RECOMMENDATION MEETING

**5206 17th Avenue NW
Seattle, WA 98107**

3039194-LU

08.21.2023

EXHIBIT 1 - MERGING OF EDG OPTIONS 1 AND 3

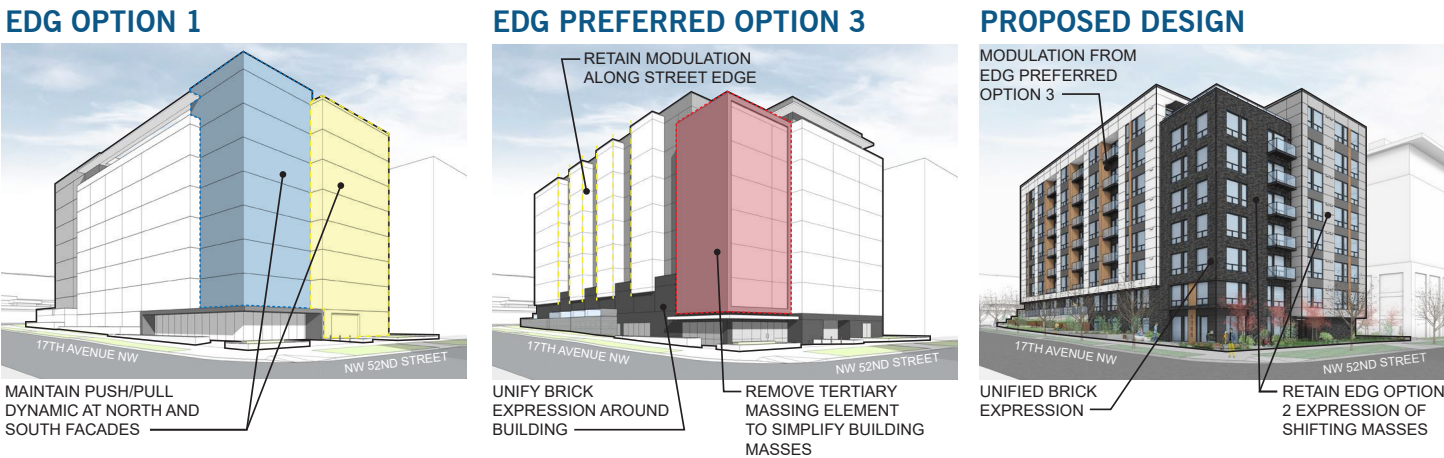
The Board specifically noted that the proposal, located in the Residential In-town zone in the Ballard Neighborhood Design Guidelines, should emphasize a strong base to ground the building in order to support the detail of the upper level modulations. They noted the base should be developed to integrate the ground level terracing along 17 Ave NW and the entry plaza at the southwest corner. CS3-1-e. Unified Design, DC2-2-b. Horizontal Divisions

Refer to Exhibit 1. From further development and combination of options 1 and 3, we’ve created stronger base by extending the SW corner massing down to grade where it ties into the level 1 façade along 17th Ave and 53rd Street facades and the NE corner massing. Material is brick to emphasize a more solid mass. The terrace and planter walls along NW 17th Avenue and 53rd Street NW have been revised with more articulation and terracing up against the building.

EXHIBIT 2 - SIMPLIFIED ARCHITECTURAL CONCEPT

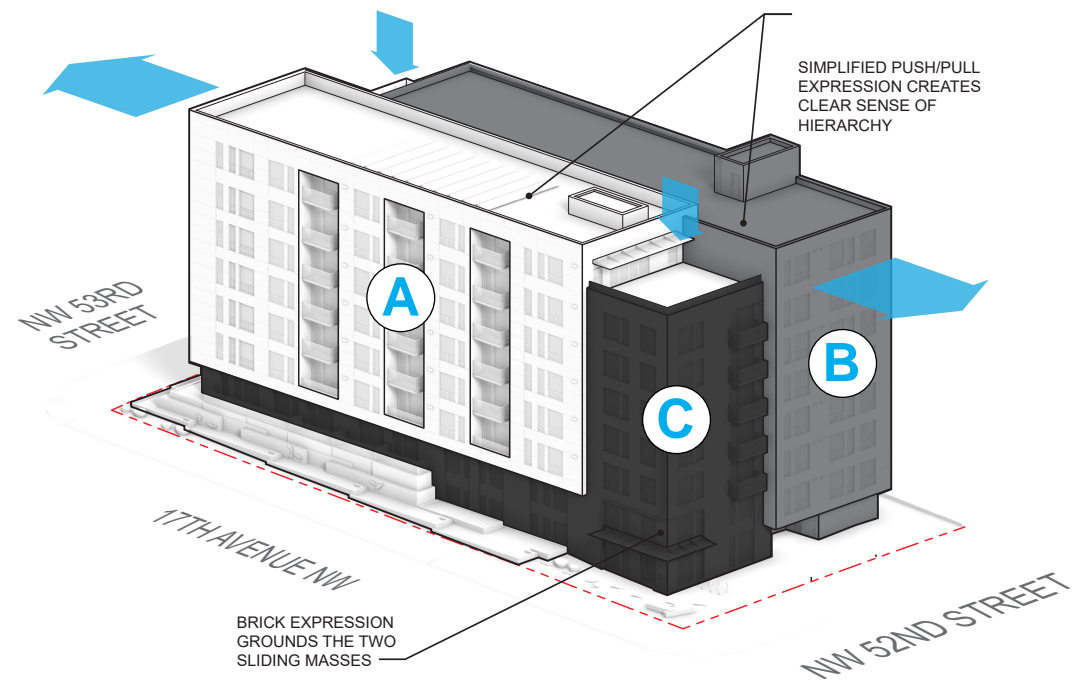
The Board noted that the upper levels lacked hierarchy which diluted a strong architectural concept. The Board requested further study of the upper level modulations at the recommendation phase, demonstrating how the proposed modulations provide design concept clarity and relate to the logic of the massing moves. DC2-B-1. Façade Composition

Refer to Exhibit 2. The upper level massing is more defined with the brick SW and NE corners rising up from grade to the top level terraces and providing a separation for the east and west shifting masses.

EXHIBIT 7 - STREETScape DESIGN ALONG 17TH AVENUE NW

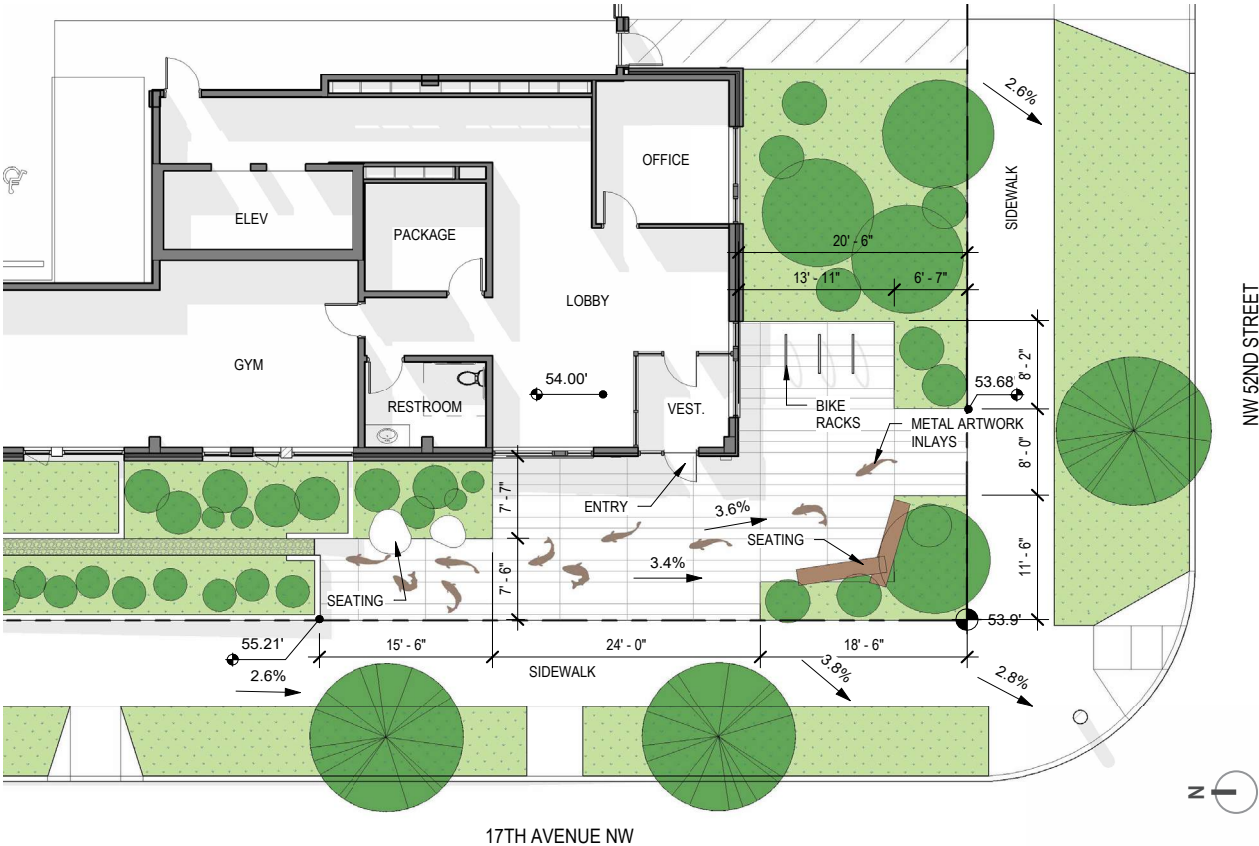
The Board agreed that locating the entry at the southwest appeared to be the best opportunity on the site to create an open area for interaction. The Board questioned how the level of the entry at the southwest corner related to the grades along 17th Ave NW as well as along NW 52nd St. They requested studies of the corner entry plaza area at the Recommendation phase to clearly show the relationships to adjacent grades of the sloping sidewalk, locations of access, the depth of the plaza space, and depth of space at the lobby that would enhance the usability of the outdoor space. PL1-1-b. Adding to Public Life, DC3-2 Open Space Uses and Activities, DC3-A Building-Open Space Relationship

Refer to Exhibits 7 and 8. The southwest entry plaza now extends out to the sidewalk without stairs or ramps for a better connection to the entry and lobby. Raised planters have been removed for better visibility into the space and seating protected by landscaping helps create a more comfortable pedestrian environment. Per the Board’s guidance, the vestibule has moved to the southwest corner and opens onto 17th Avenue NW. This allows for more landscaping along NW 52nd Street and a needed buffer between the corner entry and the parking garage entry. Additionally short-term bike racks are a now out of the way of pedestrian access while remaining visible to the street.

EXHIBIT 8 - STREETScape IMPROVEMENTS AROUND SITE

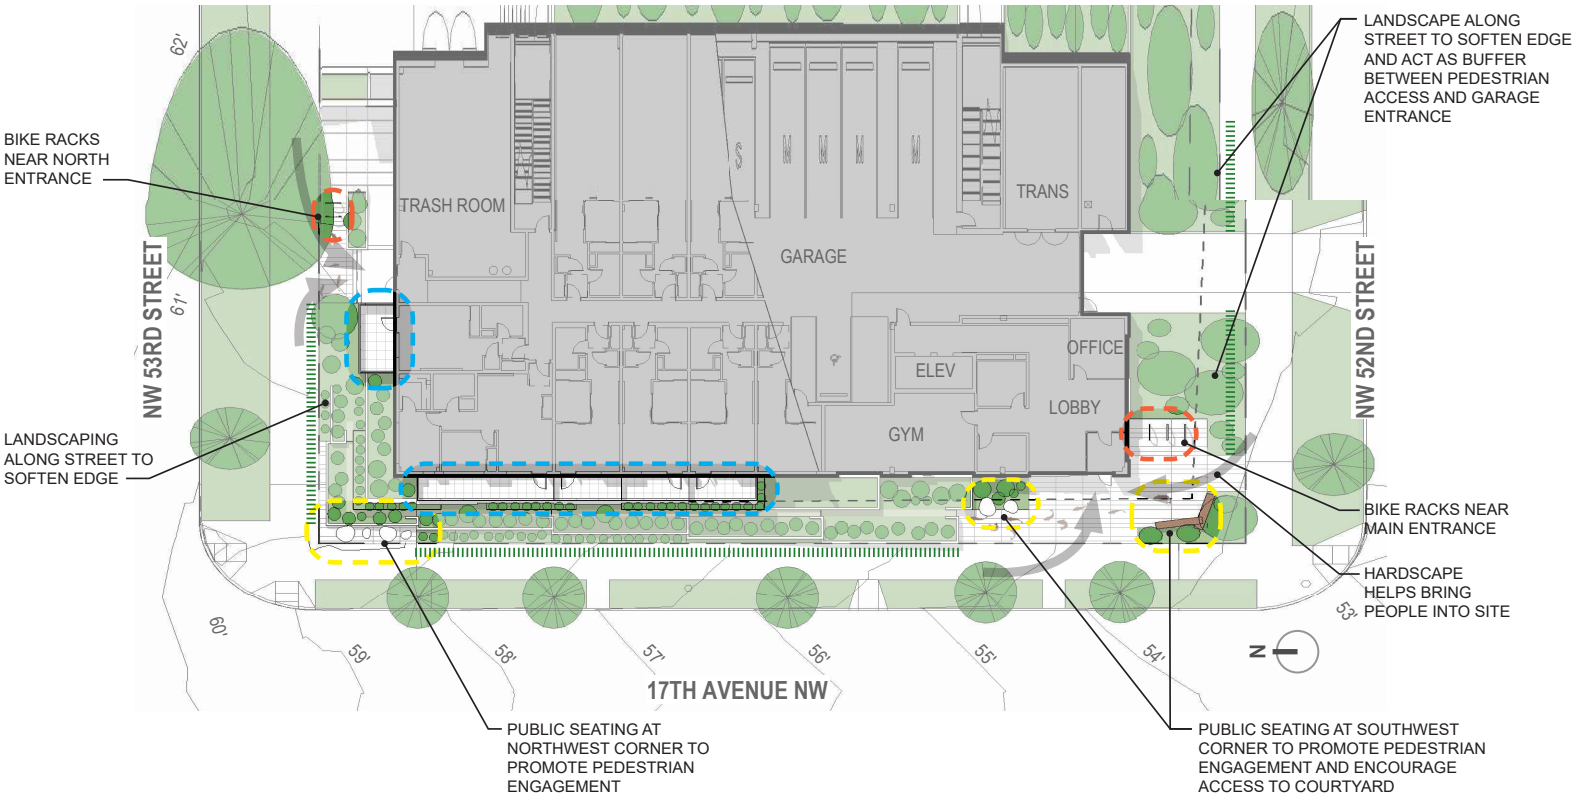
The Board noted that on a full block site with three frontages, the façade and streetscape design should be an engaging along all three street facades. At the Recommendation phase, the Board requested illustrations showing the connections along the street frontages, noting that the edges should feel visually permeable and activated. The Board noted that usable outdoor spaces are important to add residential scale to the building. PL1-1-b. Adding to Public Life, PL3-A Entries, DC3-2 Open Space Uses and Activities

Refer to Exhibits 8, 9, and 10. Several improvements along all three street-facing facades were implemented to enhance pedestrian interaction with the site and make the space feel activated. This includes the addition of public seating, adding a second entrance on the north side of the building, and relocating the main entrance to the west. Additionally, ample landscaping is proposed on all three sides to soften the building’s residential edges and enhance the pedestrian experience.

EXHIBIT 9 - ARRANGEMENT OF PROGRAM

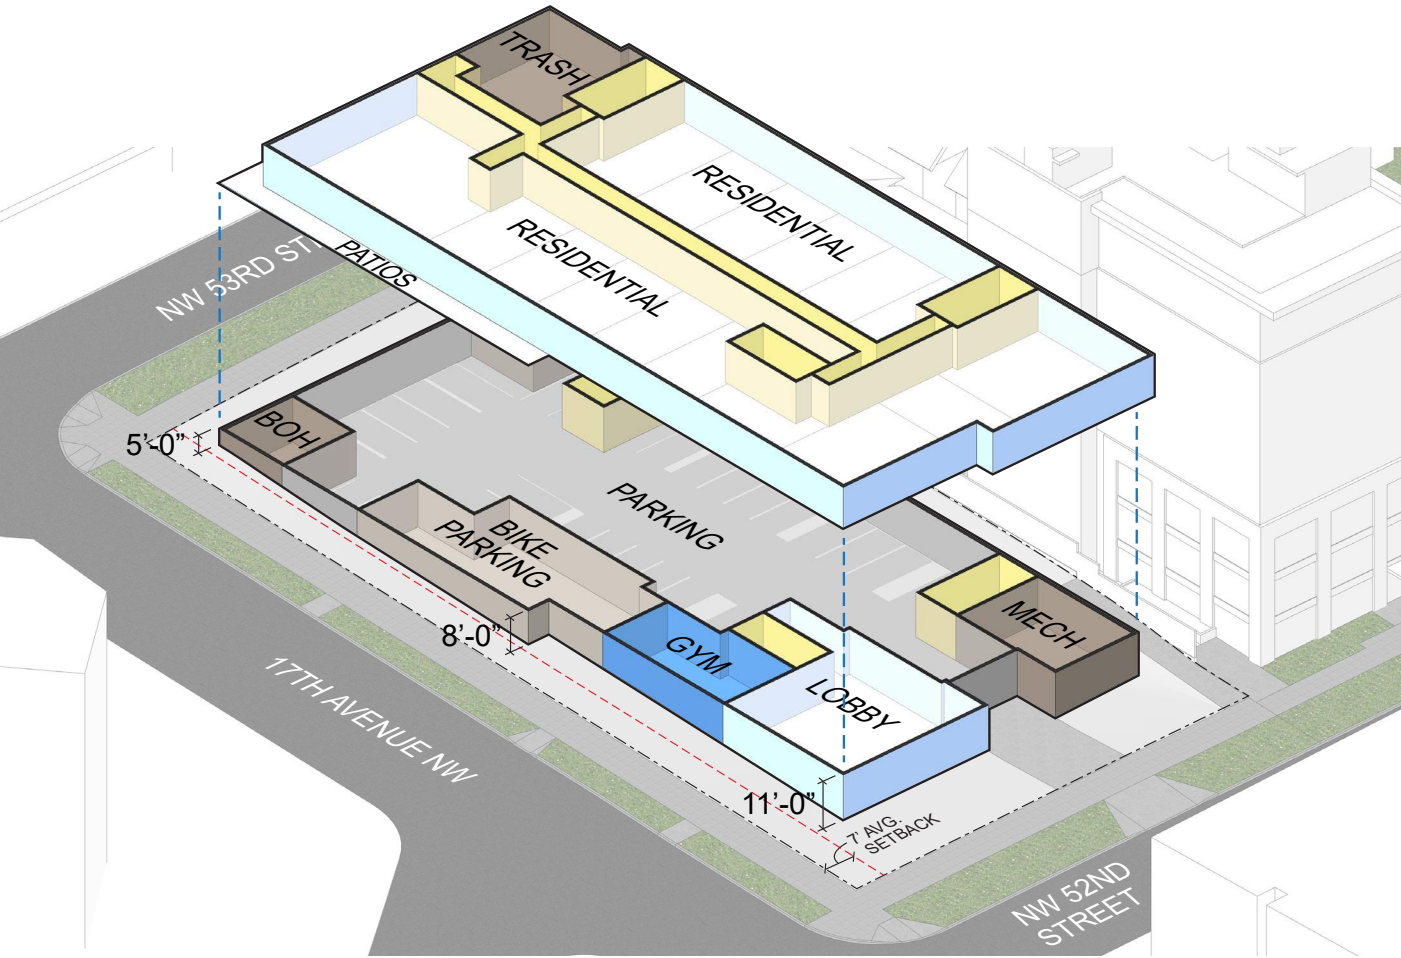
The Board asked about the height of the separation of the first level units to the sidewalk grade along the 17th Ave NW frontage. The applicant noted that as the parking and service are tucked into the slope of the site and are partially underground, the first level ranged from 3-5’ above the grade along the west frontage. The Board noted that elevated terraces could activate the streetscape but asked for further refinement of the design of the terracing, especially as they can be related and integrated into the language of the architecture. At the Recommendation phase of review, the Board would like to see studies showing how private patios will activate the streetscape. PL3-2 Residential Edges, DC3-3-a. Amenities and Features, PL1-1-b. Adding to Public Life, CS1-C Topography

Refer to Exhibits 9, 10, and 11. Exhibit 9 shows how the building’s programs stack, leaving a portion of the bike parking, garage, and mechanical above grade. Patios with landscaping along 17th Avenue NW and NW 53rd Street were determined to be the best option for masking these uses since the portions that rise above grade would be blank walls with minimal fenestration. The team wants to clarify that preferred EDG option had west-facing patios that ranged from 4’-0” - 7’-6” and not 3’-0” - 5’-0”. The proposed design raises this range to 4’-0” - 8’-0” as a result of raising the lower levels up 12” to create a better entry at the southwest corner.
